**YORK REGION –
STORMWATER MANAGEMENT
REVIEW MEETING MINUTES**

TESTON ROAD AREA TRANSPORTATION IMPROVEMENTS IEA: YORK REGION STORMWATER MANAGEMENT REVIEW MEETING

Project:	Individual Environmental Assessment and Preliminary Design for Teston Road Between Highway 400 and Bathurst Street. P-19-218	
Project No.:	1902618.00	
Place:	Teams Meeting	
Date:	March 16, 2023	Time: 3:00 - 4:00 pm
Participants:	Praveen John [PJ] Joel Smith [JS] Andrew Harkness [AH] Martin-Pierre Blouin [MB] Nick Crockford [NC] Ken Luong [KL] Jenny Dai [JD]	Region Project Manager Region Environmental Specialist MH Project Manager MH Deputy Project Manager MH EA Coordinator MH Water Resources Engineer MH Water Resources Engineer
Regrets:	Philip Brandon [PB]	Region Project Coordinator

ROLL PLAN WEST

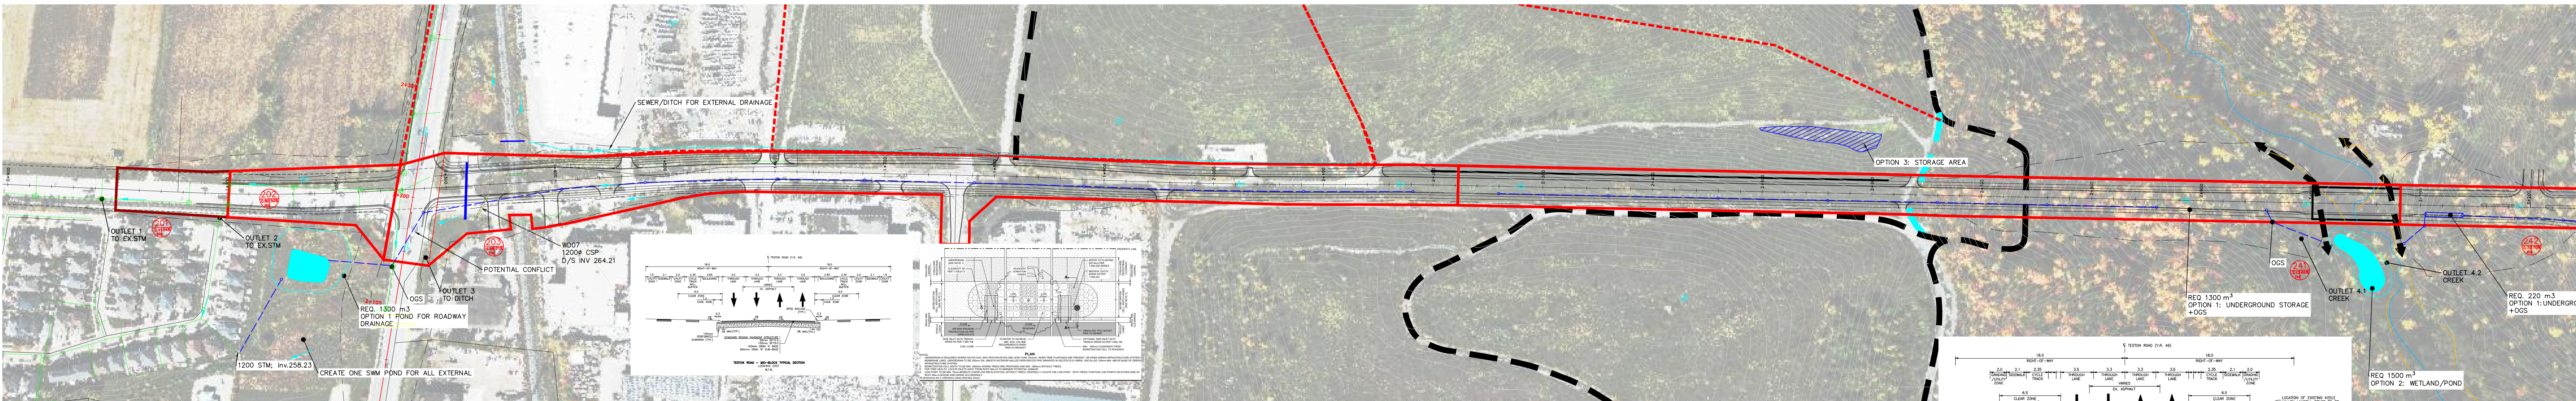
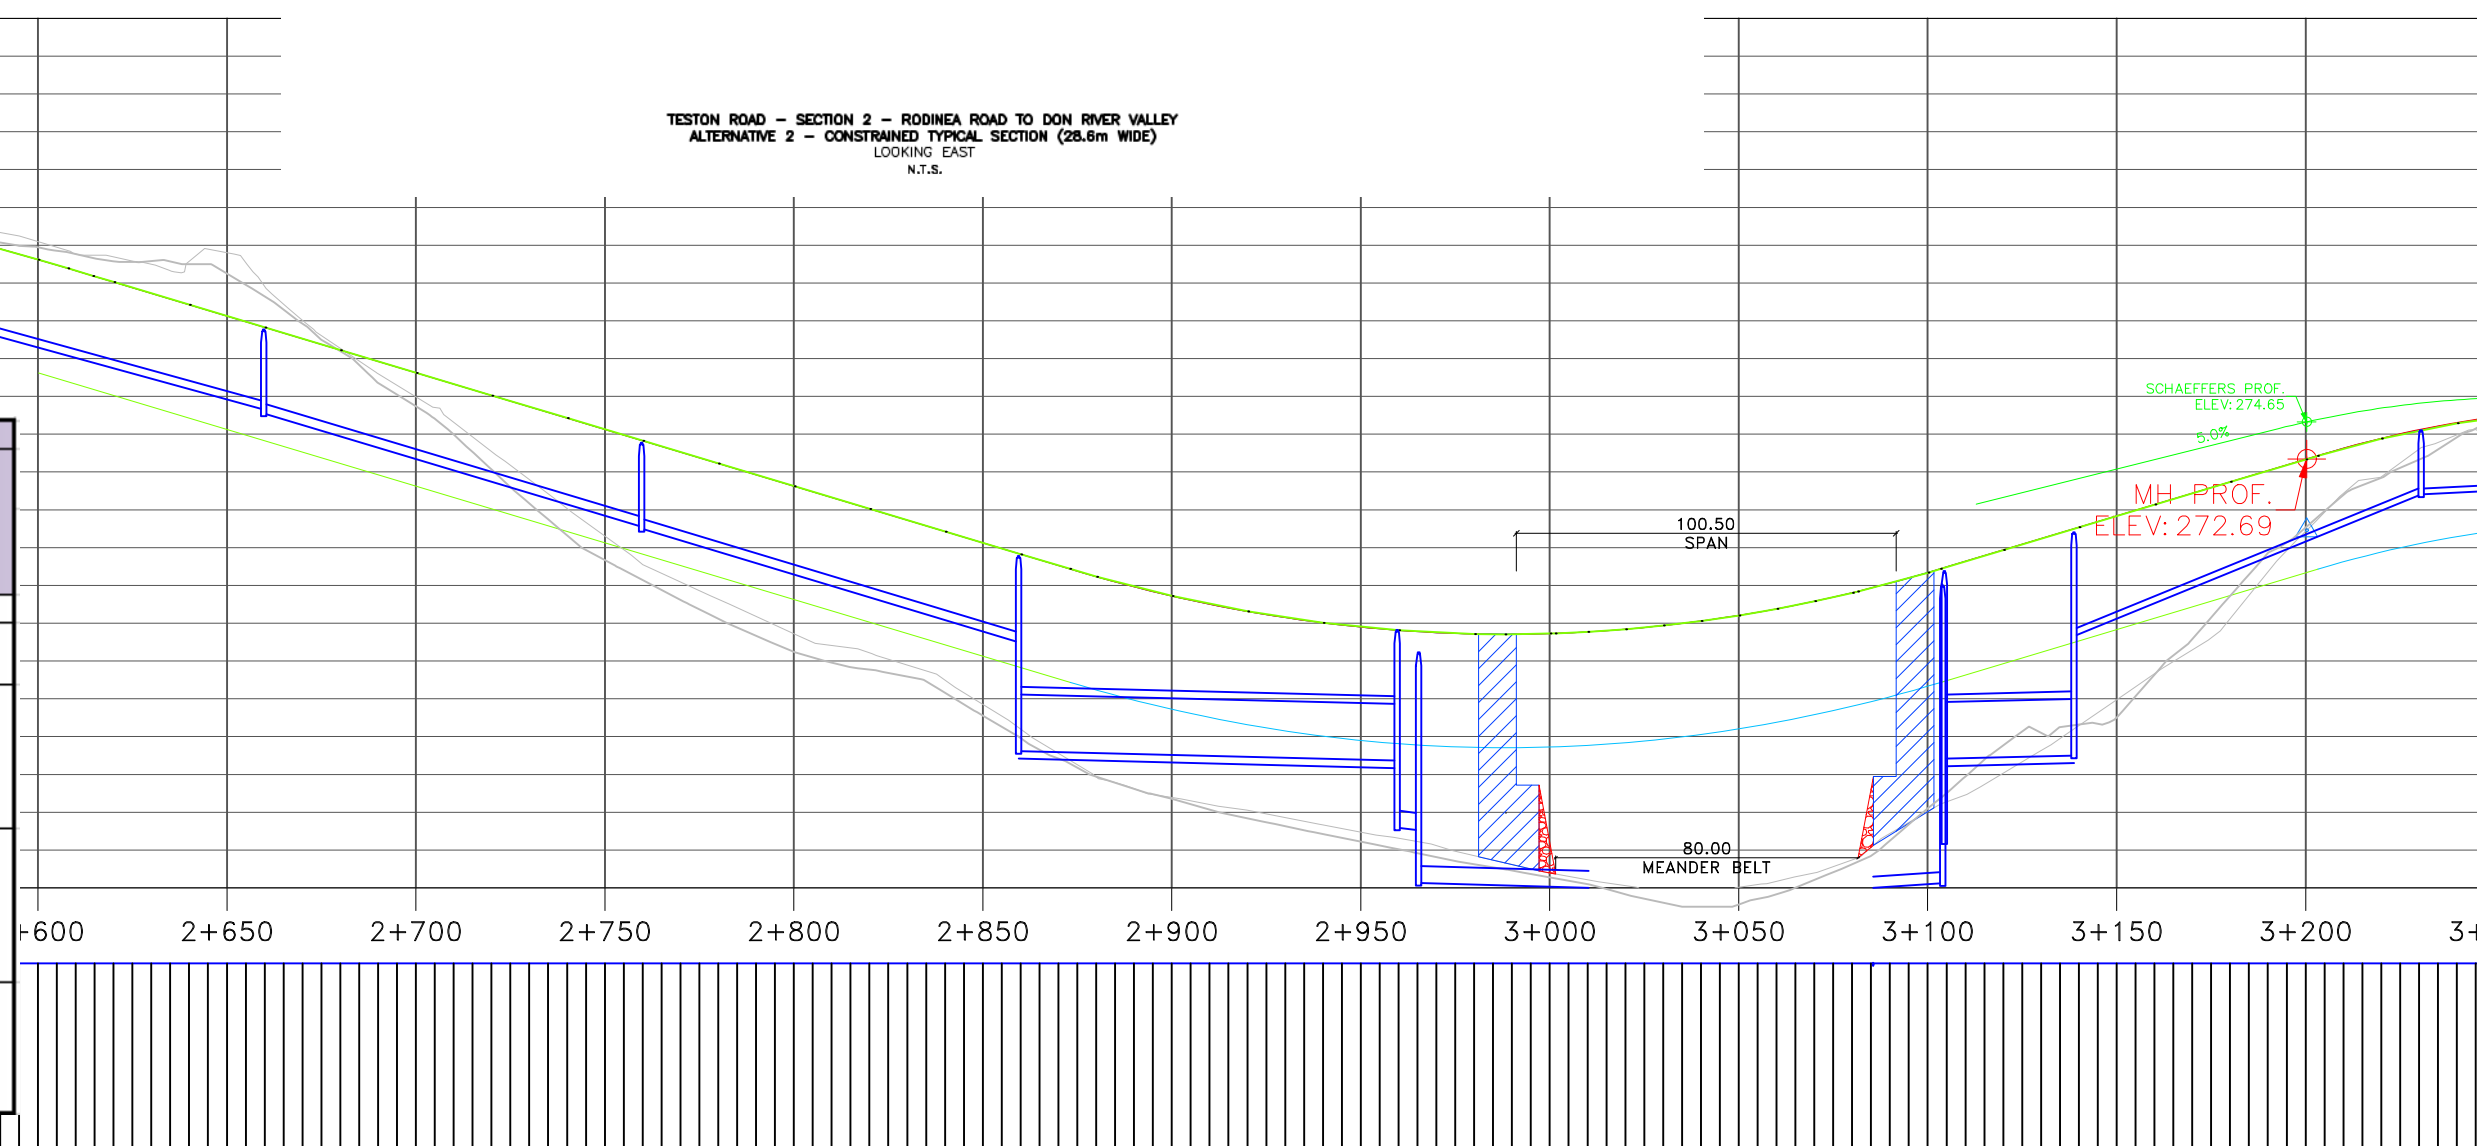
- Outlet 1 and outlet 2 present transition section west of Keele Street.
- It is anticipated that the potential impact could be minor. No SWM measure was proposed. Stormwater treatment, if required, will be combined with Outlet 3 drainage.

- ROW from Keele Street to Land Fill Area discharges to a 1200 STM east of Rosanna Cres (Outlet 3).
- Option 1 is construction of a stand-alone SWM pond to service only the ROW and keep external area flows separate, e.g., conveyed to its ultimate downstream outlet following same flow pattern as existing conditions.
- Option 2 is construction of a regional SWM pond to service all runoff from ROW and external areas.
- Both options are situated on lands that are owned by the City of Vaughan.
- York Region advised that Option 1 would be preferred.
- The use of LID features (bio-retention) within the boulevard will be investigated where feasible.

- ROW from Land Fill Area to Dufferin Street discharges to the East Don River (Outlet 4).
- Option 1 is construction of an underground storage facility.

- Option 2 is construction of a SWM pond in the valley. This option will result in a significant terrestrial / vegetation impacts to fit the pond and the access road from the ROW down into the valley.

- P. John advised that York Region preference is to not operate/maintain ponds.
- K. Luong noted that the existing pond/water feature north in the valley cannot be used for SWM purposes.

- York Region advised that Option 1 would be preferred. However, MH should document two options for further consultation with TRCA.
- Underground storage could be designed as one facility to provide quantity control and retention storage (5mm) or can be designed as separate facilities.

- For water quality, an OGS is credited with only 50% TSS removal efficiency.
- It was agreed that the combination of an OGS and 5mm retention would be considered meeting 80% TSS removal efficiency.

- Option 3 involves a small surface treatment facility in the vicinity of the landfill along the north side of the ROW.
- It was agreed that Option 3 is not preferred given the landfill constraints and that this option would not treat the entire ROW area to the outlet.

ROLL PLAN EAST

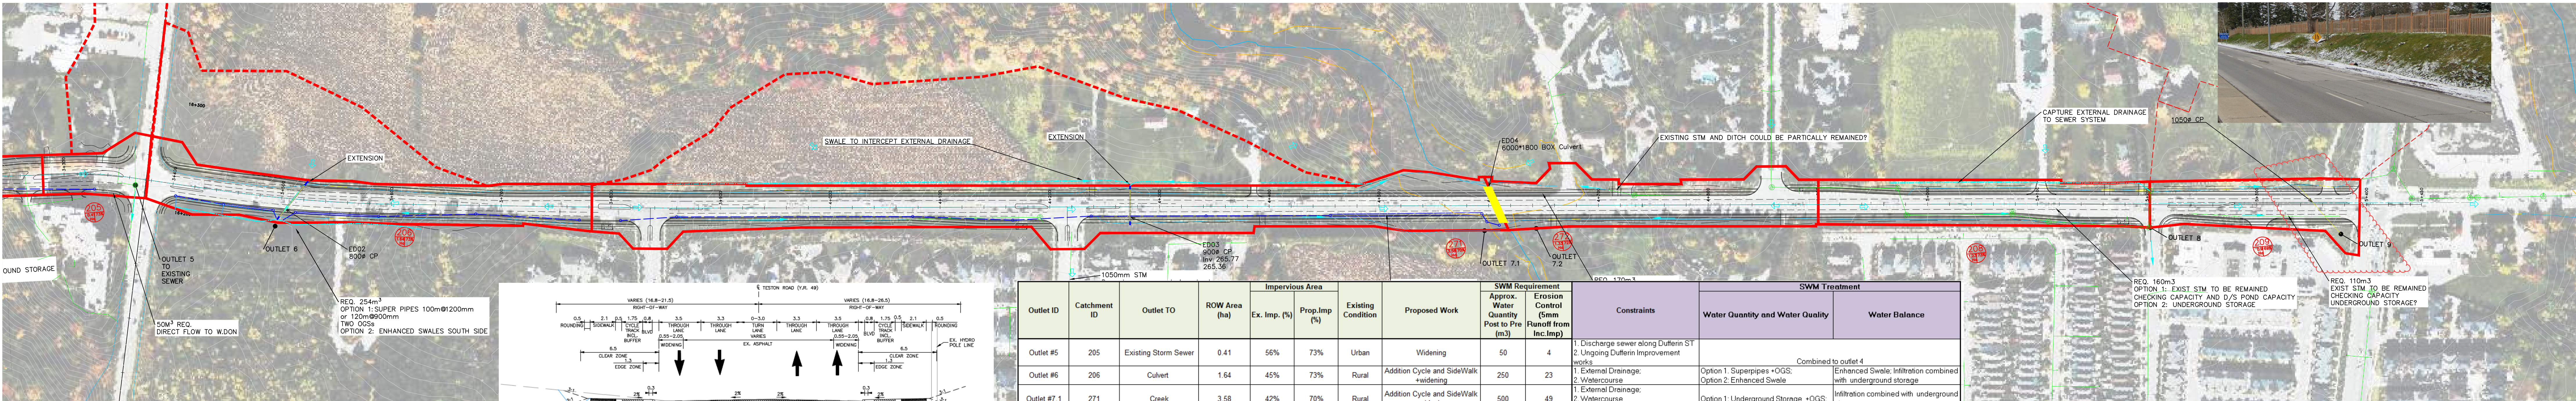
- Runoff from the Dufferin /Teston intersection discharges to a storm sewer along Dufferin Street (Outlet 5).
- Small area west of Dufferin Street and is conveyed to the future Dufferin Street storm sewer.
- Option 1: re-direct the catchment area to valley but would be a change to the existing drainage patterns.
- Option 2: maintains connection to the Dufferin Street storm sewer, as this is a small catchment, no SWM measures are proposed.

- ROW area outlets to an existing culvert, east of Dufferin Street. The culvert requires extension under proposed conditions.
- Option 1 is construction of underground storage, e.g. superpipe required on either side of the culvert for quantity control and OGS for quality control. Outlet is shallow so limited opportunities to further improve upon quality control or meet retention storage.
- Option 2 is construction of an enhanced swale on the south side of the ROW. This option can achieve quantity/quality control and retention storage and would be less costly than the underground storage.
- However, this option would be subject to grading constraints due to the large hill/back slope along the south side of the ROW. This option will have property impacts/property acquisition and terrestrial/vegetation impacts.
- Keep Option 2 for further evaluation, YR to look into property owner details.

- Outlet to valley, existing West Tributary culvert outlet.
- Need a swale to intercept external area along north ROW.
- The only feasible option is to adopt underground storage (for water quantity control and retention storage) and OGS (for water quality control).
- J. Smith emphasized that the West Tributary supports Redside Dace habitat.
- This option would bypass roadway drainage from the existing 1050 mm sewer. Information related to the 1050mm sewer along Via Romano Blvd is to be requested from the City of Vaughan.

- There is an existing large sewer (City of Vaughan) from the existing subdivision (north of ROW) conveying flows to Outlet 8 (minor system outlet and connection to another City storm sewer which flows south through an existing subdivision).
- May need a separate sewer for Teston Rd ROW.
- Option 1 keep existing storm sewer connection but will need to verify downstream sewer capacity and existing pond capacity. Storm sewer and pond design information needed from the City.
- Option 2 is to adopt underground storage (for water quantity control and retention storage) and OGS (for water quality control), implement post-to-pre- flow controls.
- An alternative option would involve re-directing flows westward towards the watercourse but would be treated as a flow diversion.

- The only feasible option is to adopt underground storage (for water quantity control and retention storage) and OGS (for water quality control).
- Downstream outlet crossing Bathurst Street is piped and additional information is required to assess downstream sewer capacity.
- Also consider directing ROW flows east towards the watercourse on the east side of Bathurst Street.
- Some coordination needed to coordinate drainage/SWM design with the Elgin Mills Road widening project, which is also being undertaken by MH.
